Twingo

ADAPTING THE HEAT SHIELDS FOR A REINFORCED FLOOR PANEL

Following a technical change brought about by the reinforcement of the tunnel, the Parts Department will only supply reinforced body shells.

PRF4101

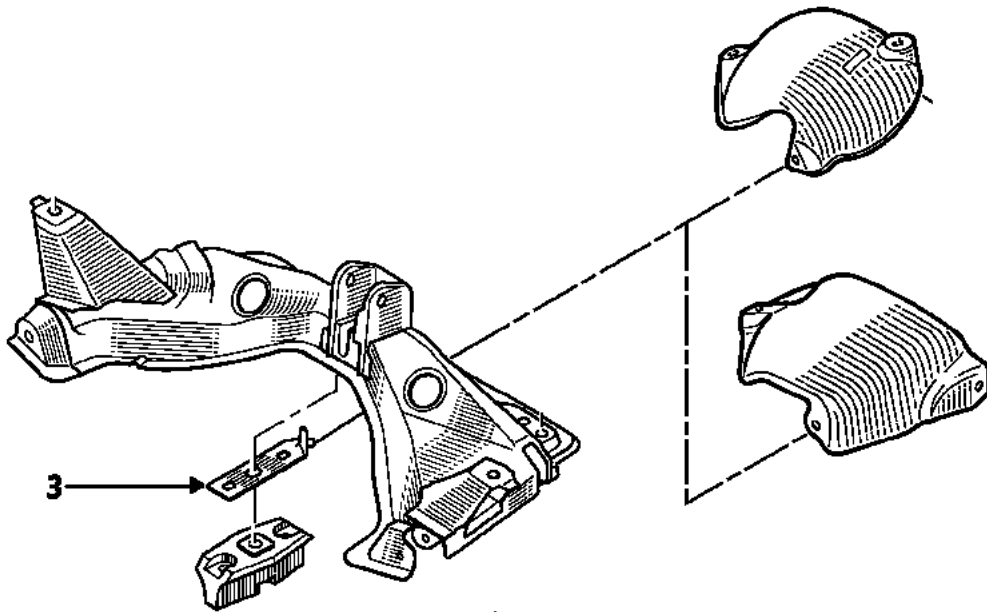
- 1 77 00 849 445 before 20 November 1995
- 2 77 00 849 193 before 1 July 1998
- 3 77 00 431 673

NOTE: The engine cradle must be in situ to fit the mounting bracket in position. (No. 3 in illustration on previous page.)

METHOD CONCERNING THE SCREEN (1)

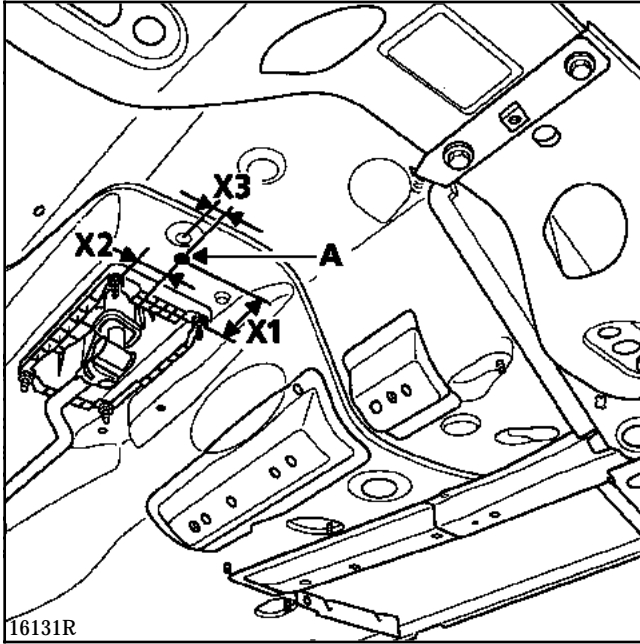
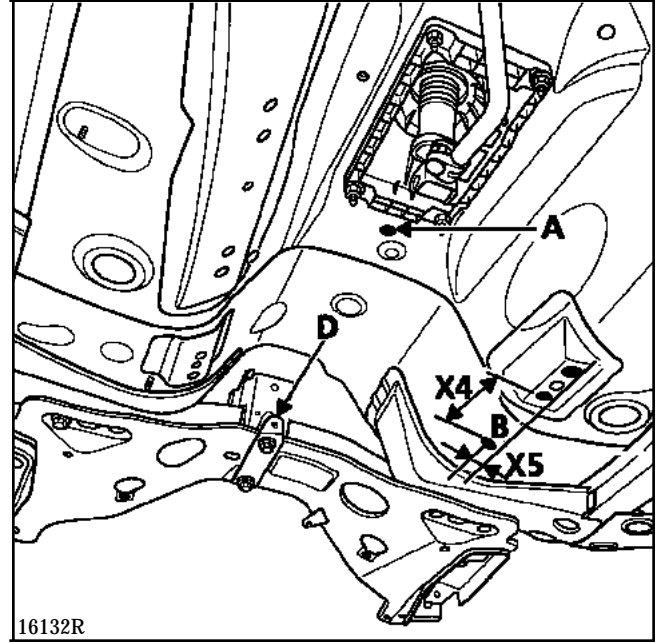
X1 = 58 mm
X2 = 44 mm
X3 = 16 mm

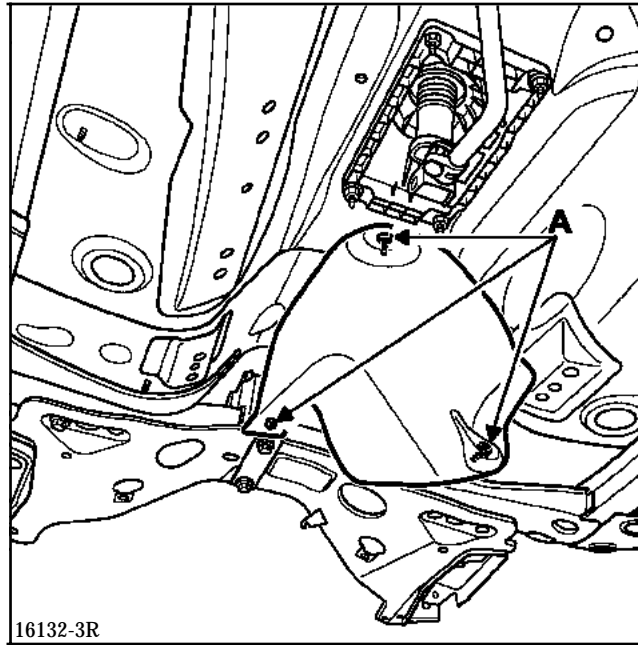
X4 = 131 mm
X5 = 9 mm

Place in position the heat shields secured at (A) and (D) and then drill the third mounting point from the other side (B). Dimensions X4 and X5 are given for information only.

METHOD CONCERNING THE SCREEN (2)

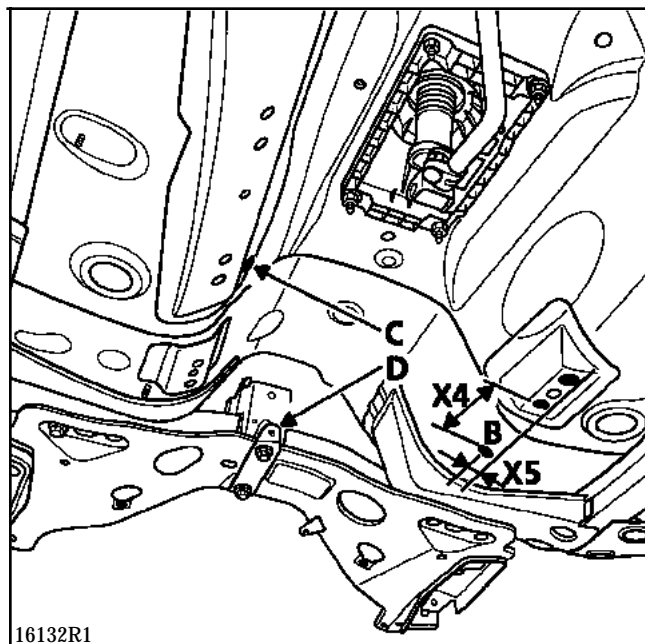
NOTE: The engine cradle must be in situ to fit the mounting bracket in position (3).

X6 = 12 mm
X7 = 37 mm

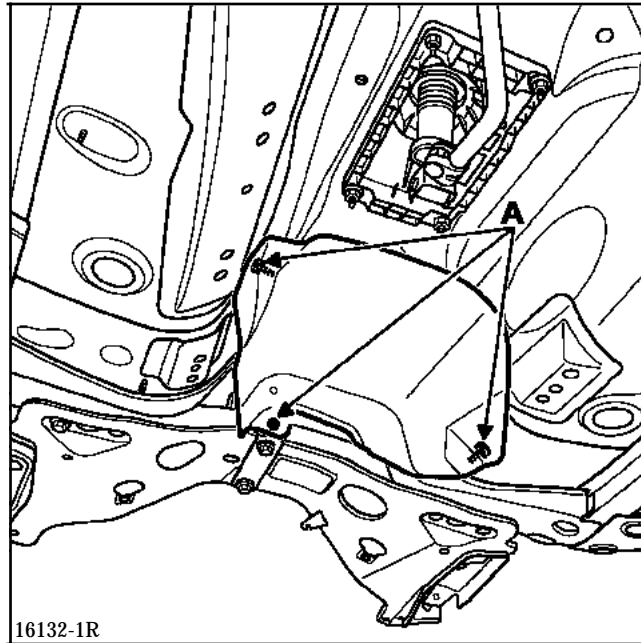
X4 = 131 mm
X5 = 9 mm

Place in position the heat shields secured at (C) and (D) and then drill the third mounting point from the other side (B). Dimensions X4 and X5 are given for information only.

NEW MOUNTING OF RETURN SPRING FOR GEAR LEVER

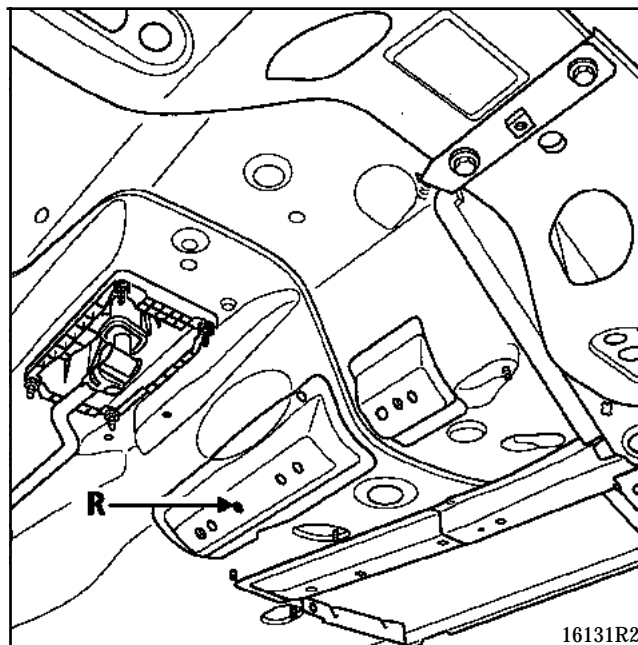
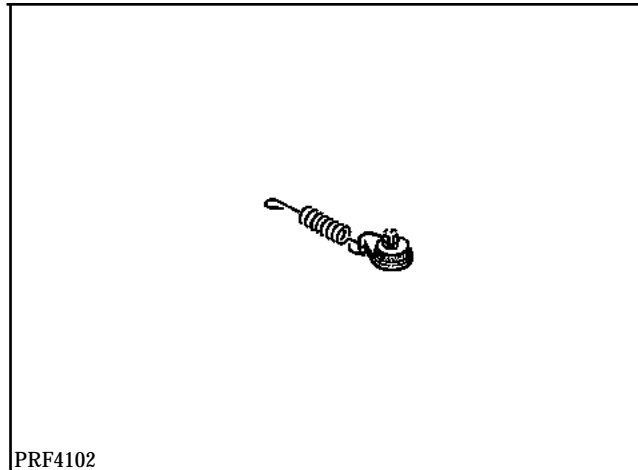
As a result, so that the various heat shields for old versions can be adapted for these new body shells, special inserts must be fitted so that these old shields can be mounted. The position of the mounting for the gear lever return spring has changed.

Part Number: 77 01 682 606

COMPOSITION OF THE PART FROM THE PARTS DEPARTMENT.

R Mounting point
